City of Sandy

Planning Commission Meeting

Meeting Date: Monday, April 8, 2019

3. PUBLIC HEARING – Type III Subdivision for Jacoby Heights Subdivision (18-025 SUB/VAR/TREE/FSH/INT) Chairman Crosby opened the public hearing on File No. 18-025 SUB/VAR/TREE/FSH/INT (Jacoby Heights Subdivision) at 7:01 p.m. Crosby noted that this is a quasi-judicial public hearing. He called for any abstentions, conflicts of interest, ex-parte contact, challenges to the jurisdiction of the Planning Commission, or any challenges to any individual member of the Planning Commission.

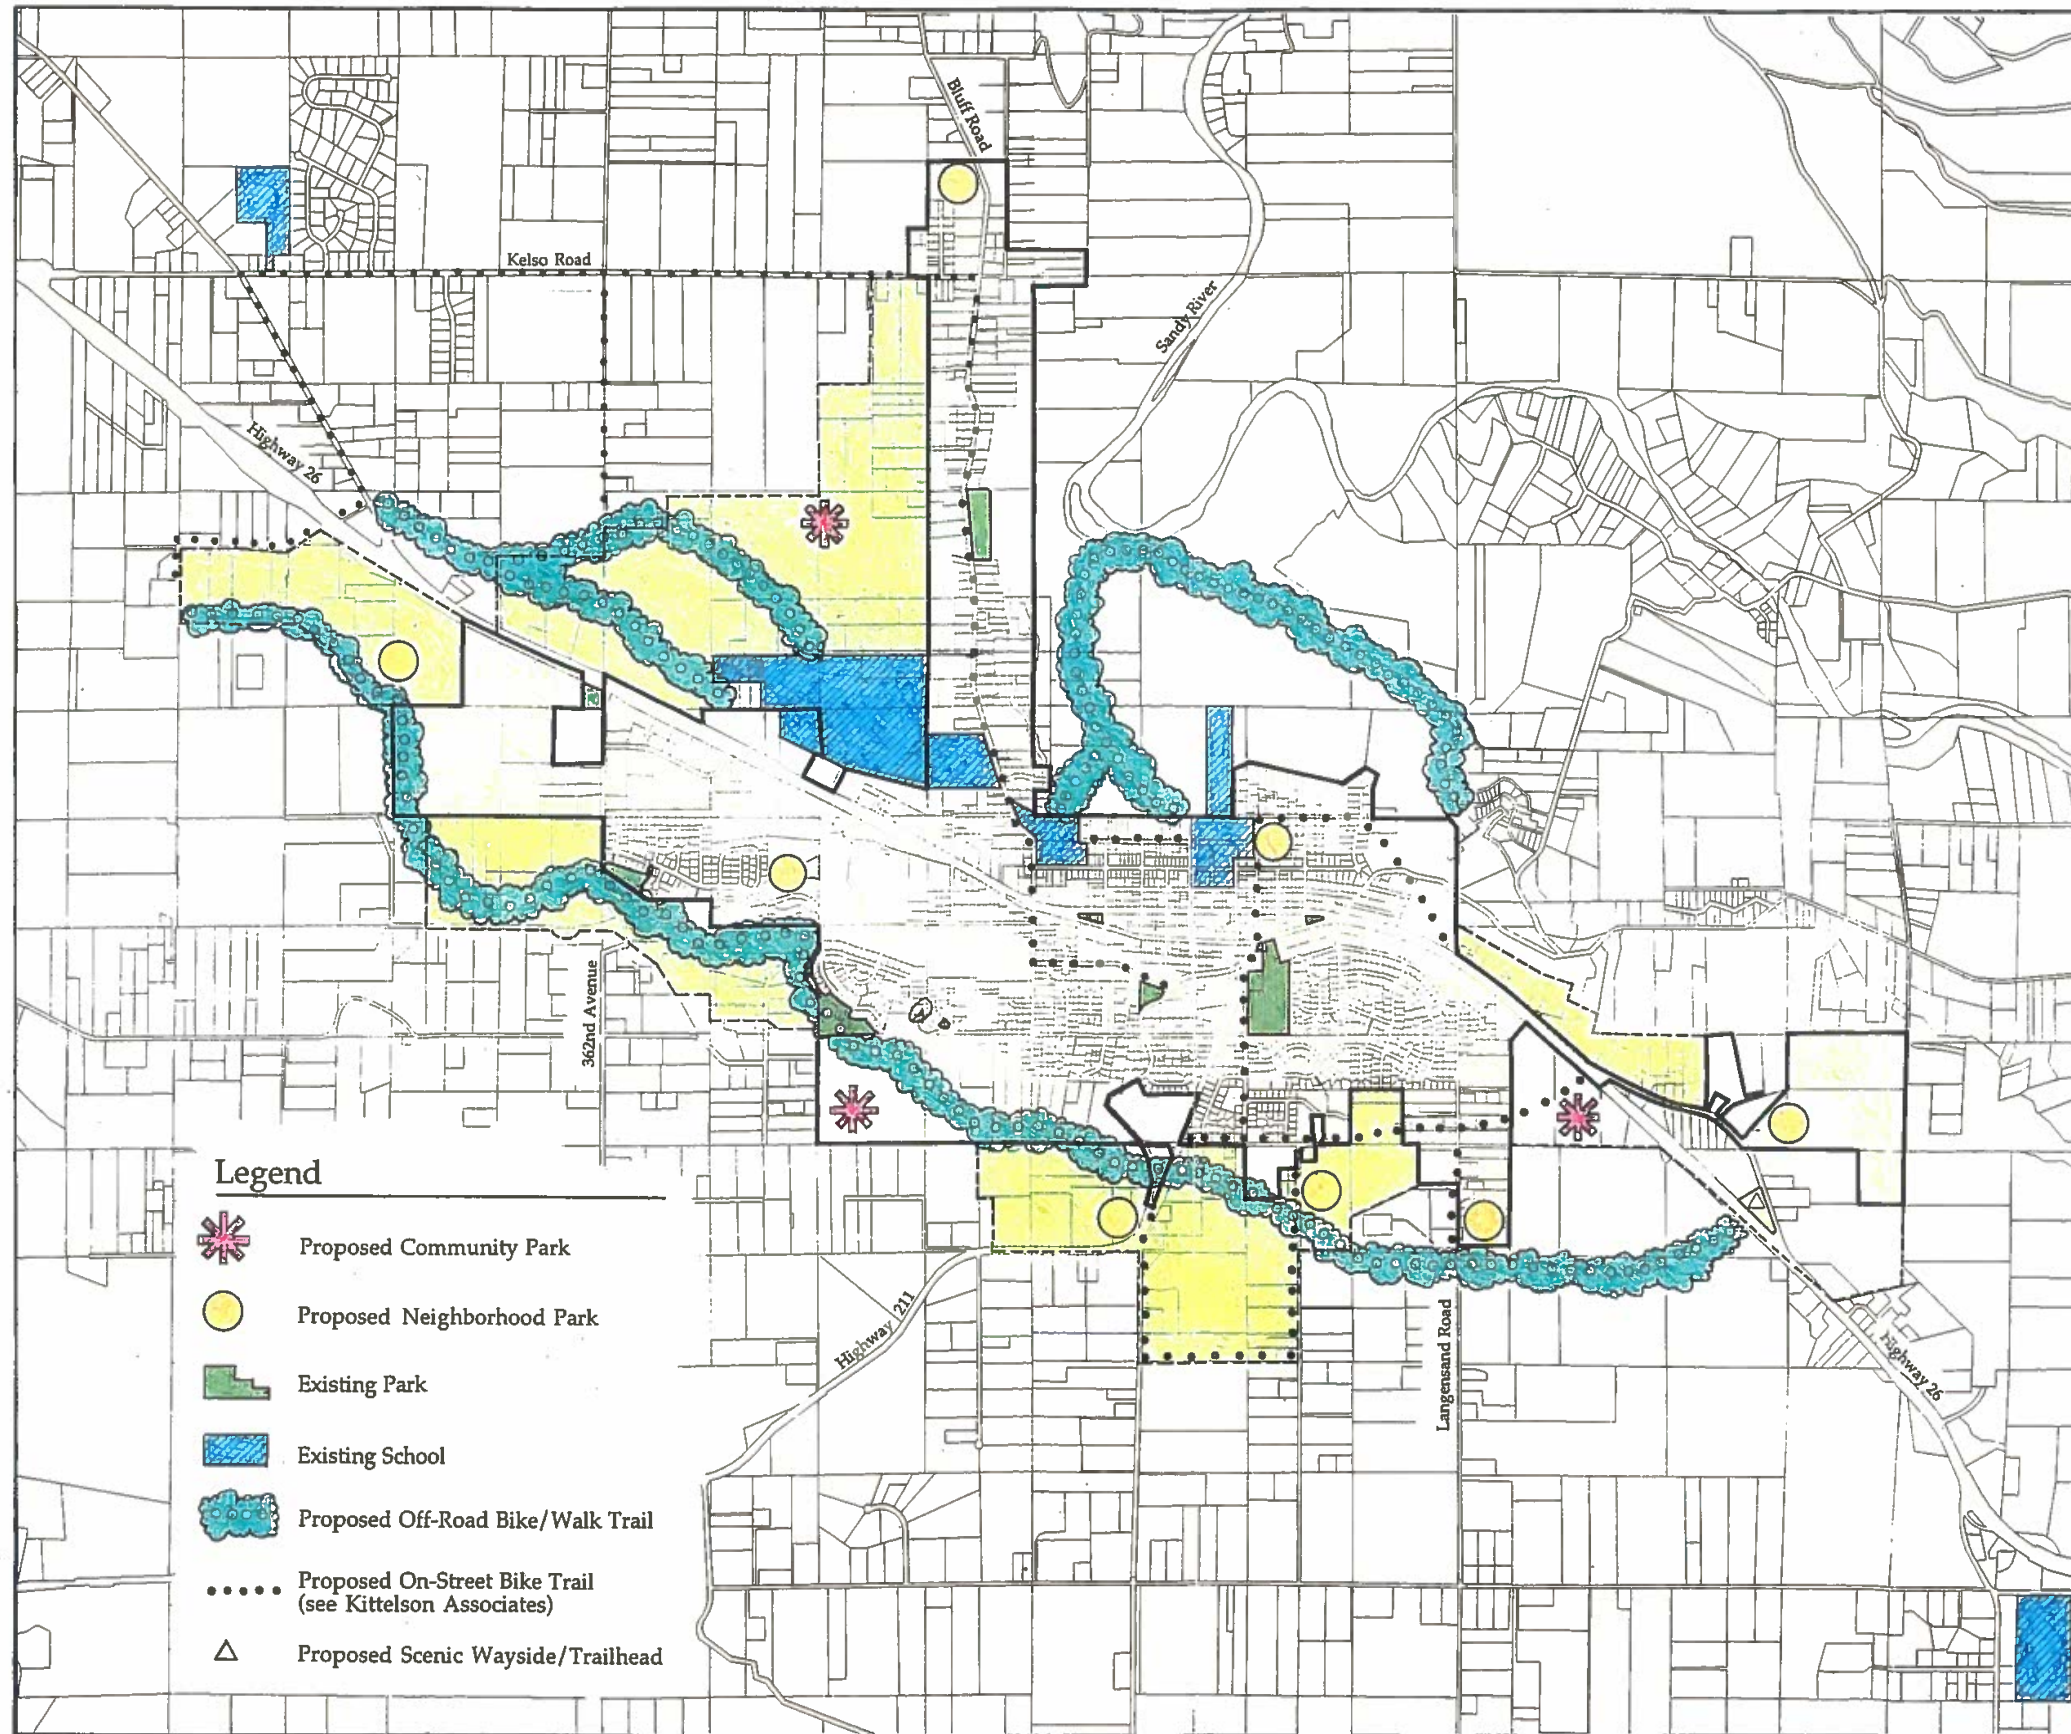
Response: This condition cannot be met. The existing street grade and sidewalk on Jacoby Road at this location is approximately 7.5%. This exceeds the 2% landing that is required to meet ADA. Please remove this condition.

This location isn't at an intersection – the condition is requiring a mid-block ramp on the existing street opposite the proposed intersection. Regardless, this standard should be easily achievable if the street grade is 7.5%. The ODOT standard detail (attached) allows a 15' long transition between the landing and the point where the existing street grade is matched. I recommend that the condition be left as is.
